Approval and Promulgation of Implementation Plans; North Dakota; Regional Haze State Implementation Plan; Federal Implementation Plan for Interstate Transport of Pollution Affecting Visibility and Regional Haze; Final Rule

[EPA-R08-OAR-2010-0406; FRL-9648-3]

Approval and Promulgation of Implementation Plans; North Dakota; Regional Haze State Implementation Plan; Federal Implementation Plan for Interstate Transport of Pollution Affecting Visibility and Regional Haze**AGENCY:** Environmental Protection Agency (EPA).**ACTION:** Final rule.

Figure 1. Coal-Fired Boilers Operating Below 0.17 lb/MMBtu

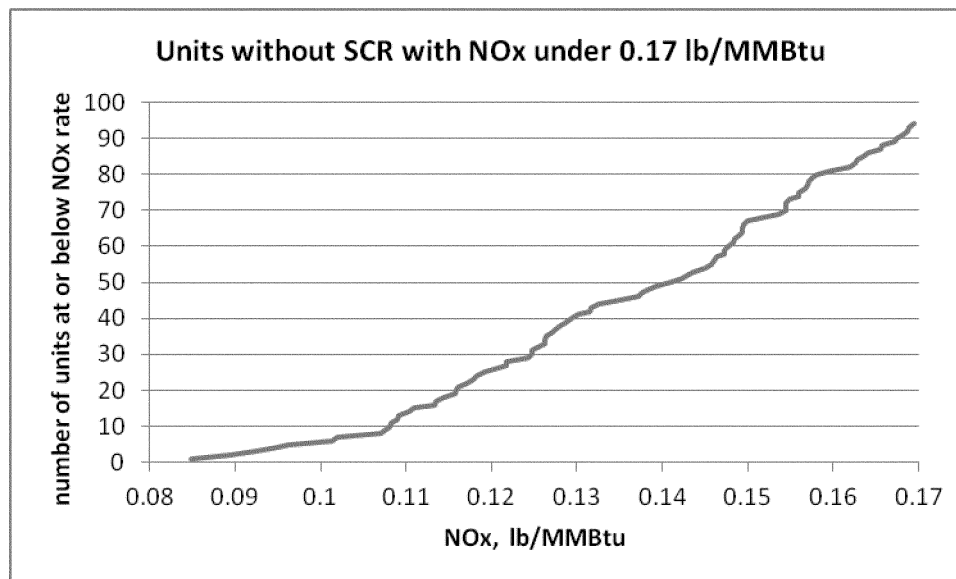
Analysis of emissions data found significant discrepancies in Figures 2.2 and 2.3 of GRE's November 2011 Refined Analysis. A review of EPA Title IV data for 2010 showed 94 coal-fired boilers that do not have SCR achieve annual emissions levels below 0.17 lb/MMBtu, with the median slightly under 0.14 lb/MMBtu (see Figure 1 below). Of these, ten of them are using SNCR in combination with combustion controls to achieve under 0.17 lb/MMBtu. See docket for a list of these facilities. Of these ten, three are supercritical tangentially-fired boilers that use lignite coal with emissions below 0.14 lb/MMBtu. These include Big Brown 1 and Monticello 1 and 2, as discussed earlier in our responses. In addition, the NEEDS Database v.4.10 for the Final Transport Rule in the CSAPR docket includes two tangentially-fired coal/steam units from North Carolina with LNC3 and SNCR that had emission rates of 0.159 lb/MMBtu and 0.164 lb/MMBtu.

As we explain elsewhere, we have decided to revise the BART limit from 0.12 lb/MMBtu to 0.13 lb/MMBtu on a 30-day rolling average.
